THE NAPA COUNTY REGIONAL PARK AND OPEN SPACE DISTRICT
Camp Berryessa Improvement Project

ADDENDUM Nº 3

Issued: October 2, 2014

**COMBO BUILDING
 FLOOR PLANS & ELEVATIONS**

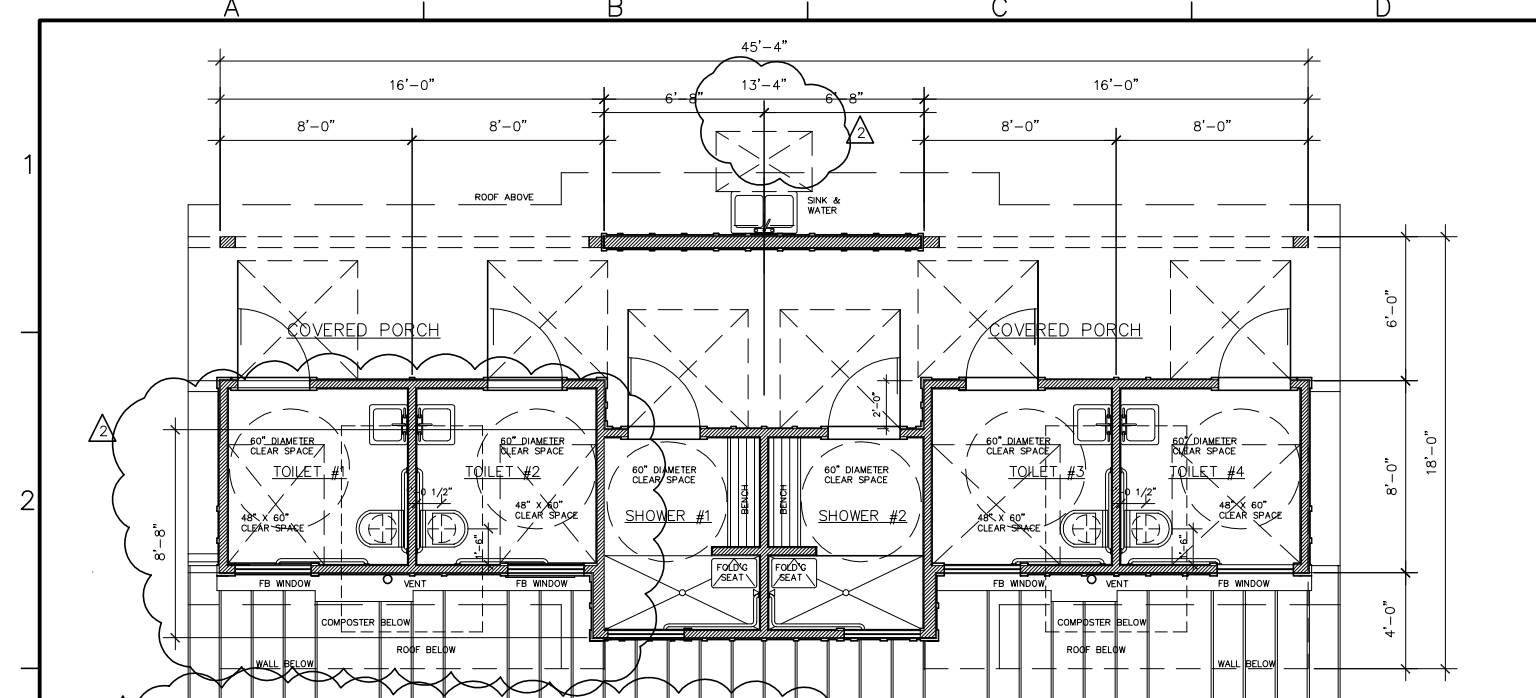
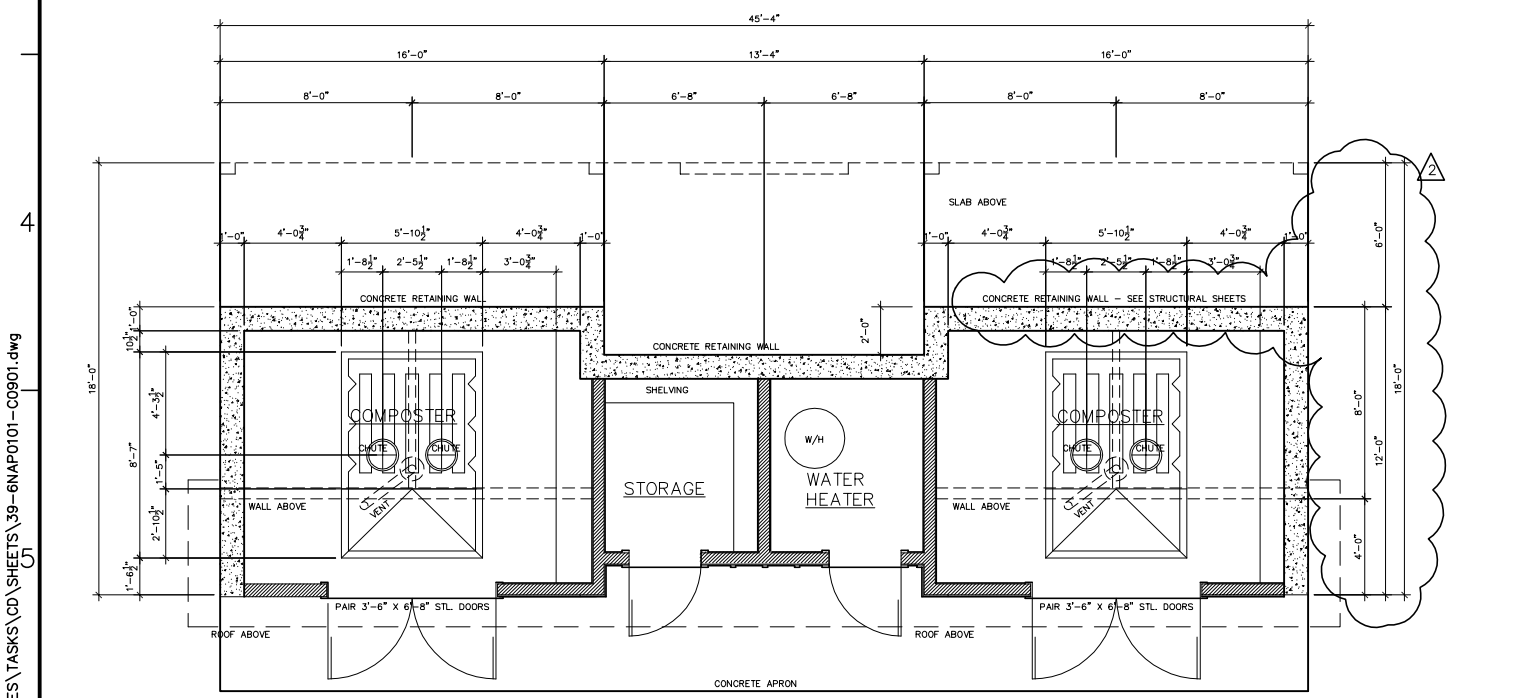
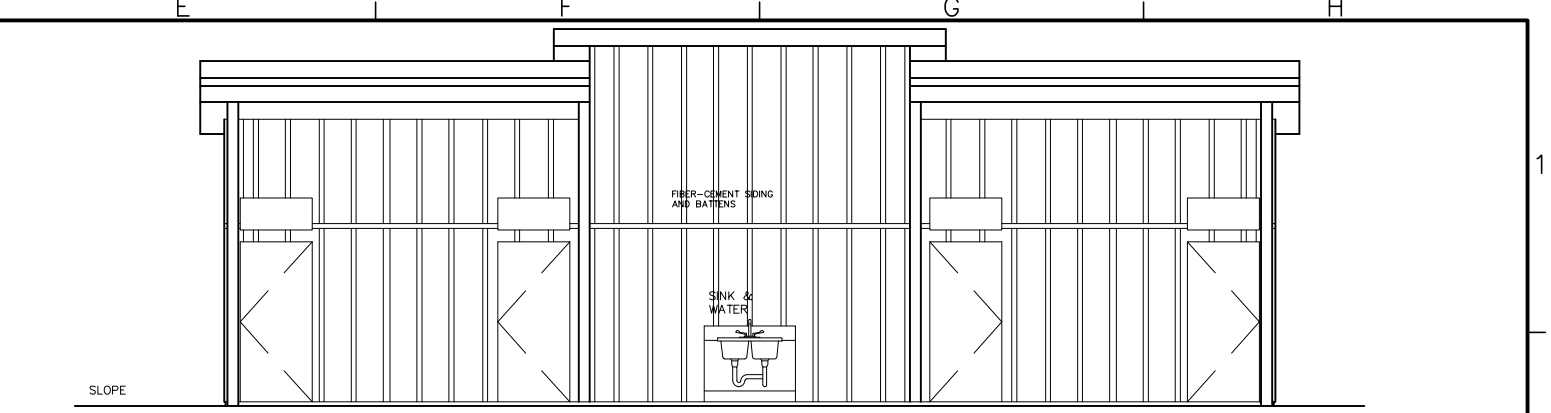
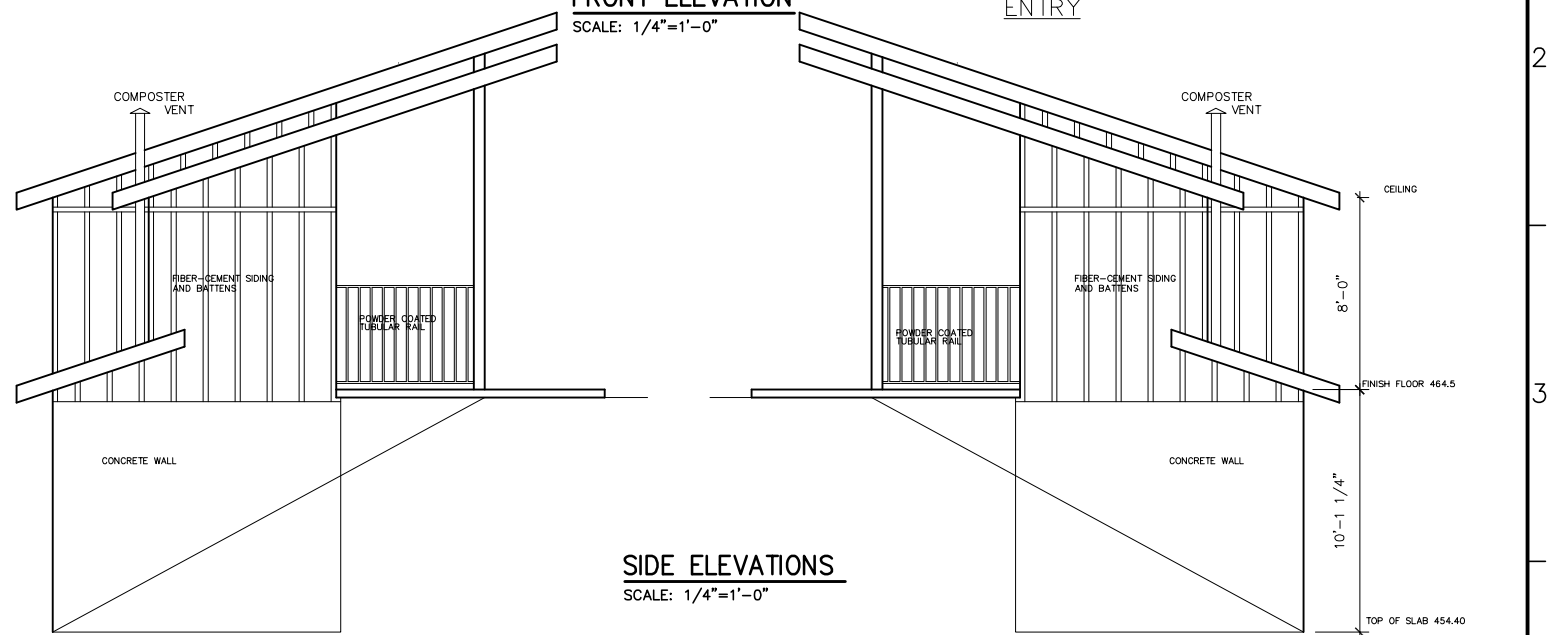
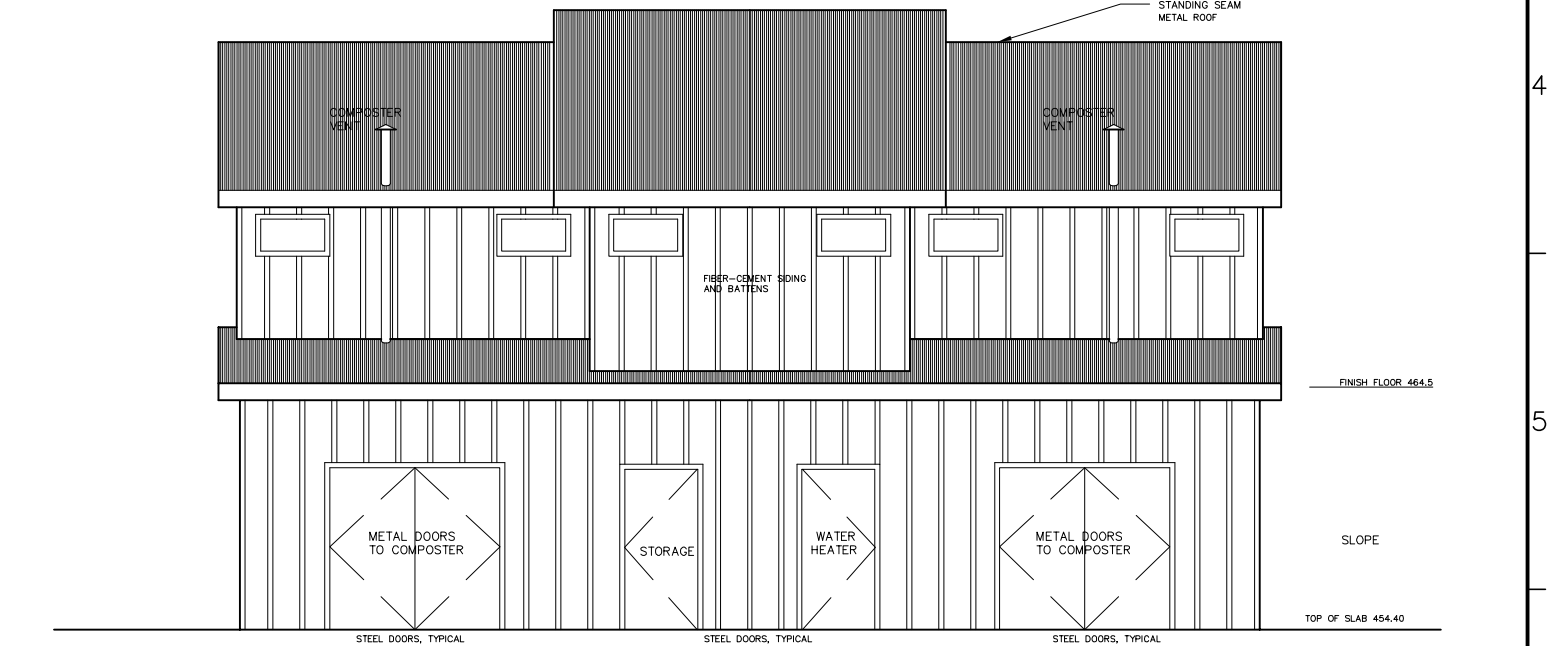
7. Question: Interior finish schedule for combo building?

Answer: see revised sheet C09.01
